MANDATORY SERVICE BULLETIN

Model DA 62

MANDATORY SERVICE BULLETIN NO. MSB62-020

Inspection of the middle and rear passenger seat lap safety belt connections.

Bolt positions to inspect Figure1 - Middle Seat

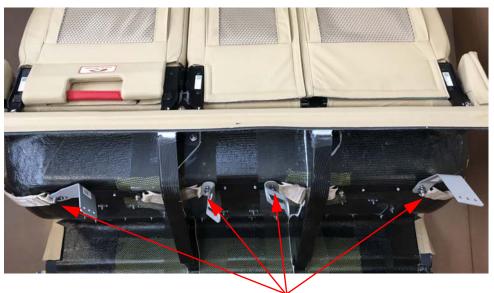
1.	Refer to AMM 7.02.25, Chapter 25-10-00, figures 2, 3 and 4
2.	Remove the seat cushions on the middle row and remove the seat access panels.
3.	Loosen the outboard bolts and the two bolts for the middle seat that attach the lap belts. (2 to 3 turns).
	NOTE: The bolt may be secured by a washer and nut or by a nutplate

4.	Pull on the lap belts to ensure they are properly attached.
5.	If the lap belt is properly attached re tighten the bolt per the AMM
6.	If it is not:
	Completely remove the bolt and reinstall the bolt ensuring the it passes through the ear of the lap belt, the metal plate and anchor plate. The lap belt ear must be between the seat pan and metal plate. See Figure 3.

Figure2 - Rear Seat

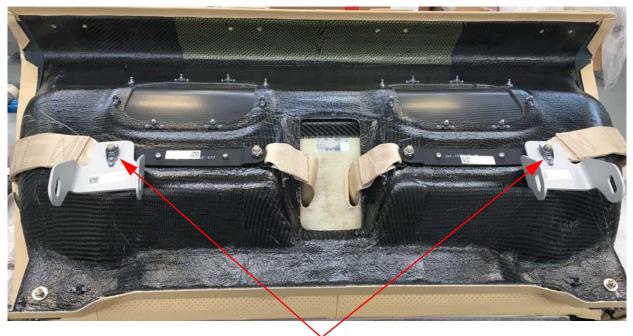
7.	Re install the bolt as per the AMM. Refer to Figure 4 of the AMM if a nut and washer are installed or to Figure 3 below if a nut plate is installed
8.	Repeat this process for the rear seat. Only the two outboard bolts need to be checked.
